Addendum No. 1

SUBJECT: Wolf Creek (Lower Grave Creek Rd) Bridge Project
Lower Grave Creek Rd.
Josephine County
Grading, Structures & Paving
(Bids Closing October 15, 2026)

CONTRACT NO.: 15697 **PROJECT:** WOLF CREEK (LOWER GRAVE CREEK RD) BRIDGE
PROJECT KEY: 23162 **ADDENDUM NO.:** 1

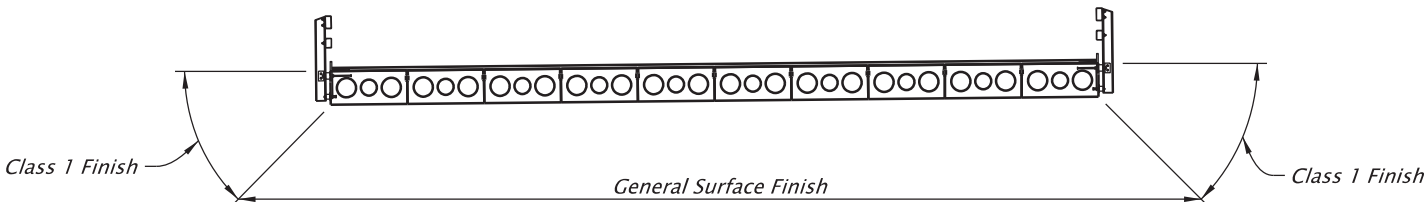
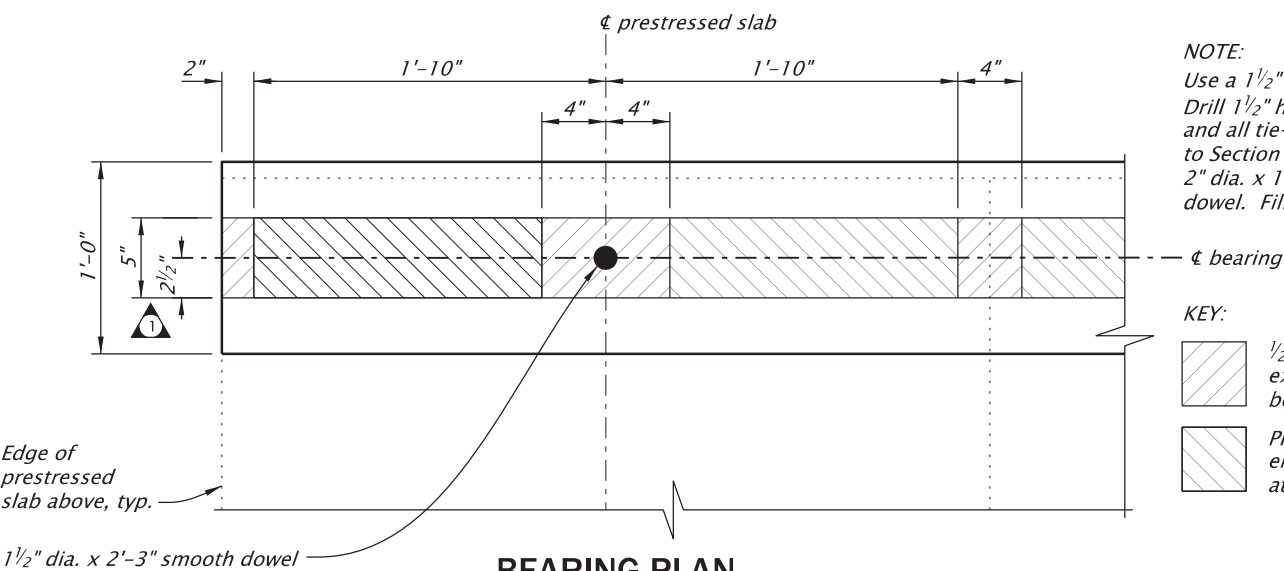
No.	DATE	REVISIONS	BY
1	10-06-26	Bearing pad update	R.M.C.

NOTE:
Use a 1 1/2" dia. x 2'-3" smooth dowel at each end of slab. Drill 1 1/2" hole 1'-0" into bent after all slabs are placed and all tie-rods are fully tightened. Drill hole according to Section 00535.40. Do not resin-bond dowel. Place a 2" dia. x 1" thick expanded polystyrene plug on top of dowel. Fill remainder of hole with non-shrink grout.

- KEY:**
- 1/2" thick x 5" preformed expansion joint filler between bearing pads
 - Place 2- 1/2" x 5" x 1'-8" elastomeric bearing pads at each slab
